**ITEM FOR ENVIRONMENTAL BOARD AGENDA**

**NAME & NUMBER OF PROJECT:** TRAVIS COUNTY EASTSIDE SERVICE CENTER  
SP-2008-0235D(R1)

**REQUEST:** Variance requests as follows:  
1. To allow construction in the Critical Water Quality Zone (LDC 25-8-392)  
2. To allow fill over 4 feet but not to exceed 8 feet (LDC 25-8-342)

**SUBJECT:** Travis County Eastside Service Center – SP-2008-0235D(R1)

-14- Exhibit 4- CWQZ and Floodplain Exhibit

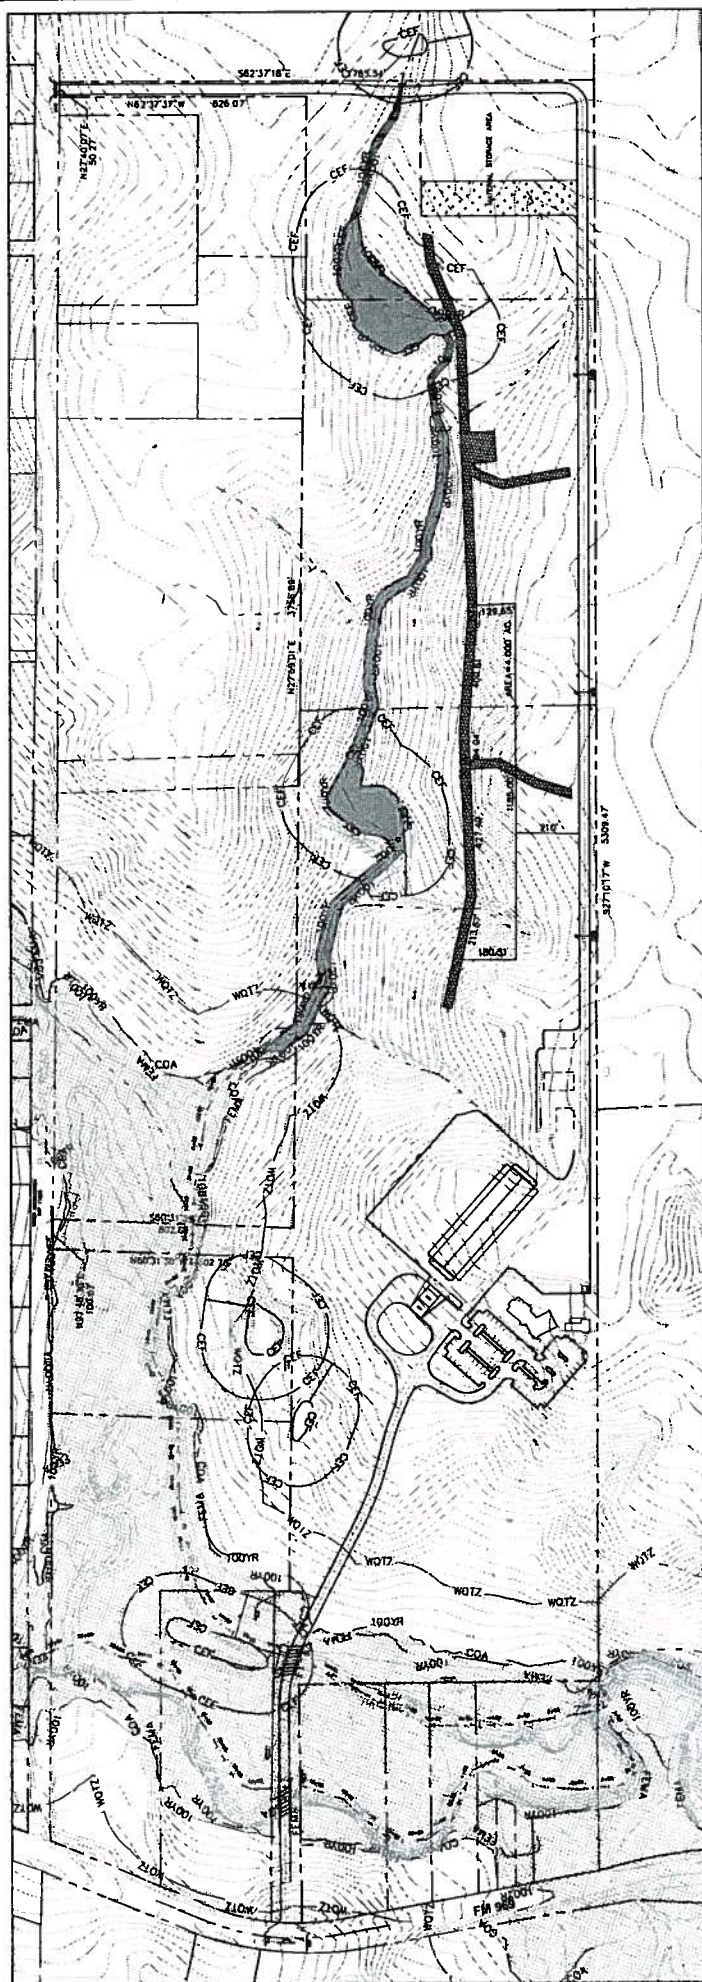
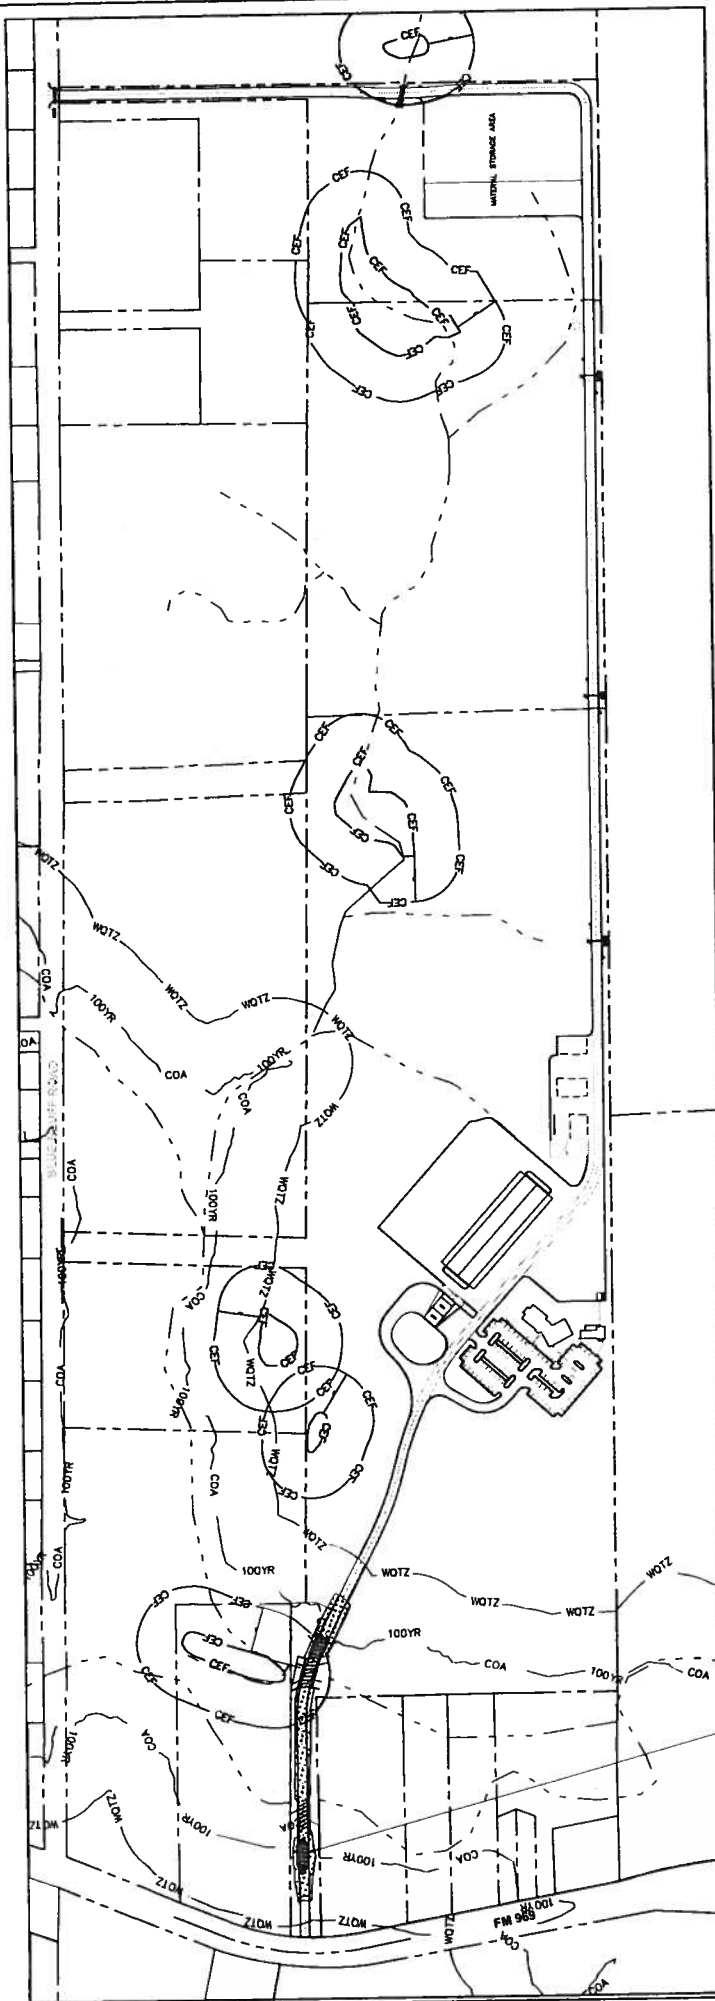
The driveway alignment crosses two approximately parallel, intermediate waterways (Exhibit 4 – Critical Water Quality Zone and Floodplain Exhibit). Within the property these waterways are adjacent to one another (approximately 450 feet apart) and converge approximately 1000 feet downstream of the property. The result of this waterway spacing within the property is that the critical water quality zones of each waterway overlap to create a single, widened critical water quality zone. The driveway alignment crosses approximately 620 feet of combined critical water quality zone. In accordance with LDC 25-8-392, a driveway may not be constructed in the critical water quality zone.

Land Development Code Section 25-8-392 states that Development is prohibited in a critical water quality zone, except as provided in Article 7, Division 1 (*Critical Water Quality Zone Restrictions*). Construction of a driveway is not one of the provisions of Article 7, Division 1. The driveway alignment crosses the critical water quality zone of two intermediate waterways.

The findings of fact for both variances have been met (Exhibit 9 – Applicant and Staff Findings of Fact). Staff recommends approval of Variance One and Variance Two with the following conditions:

1. The applicant will expand the conservation easement area from 4 contiguous acres to 5 contiguous acres; and
2. The applicant will plant at least 15 ECM Appendix F trees to be generally evenly distributed throughout existing parking lot islands and medians to help reduce the heat island effect.
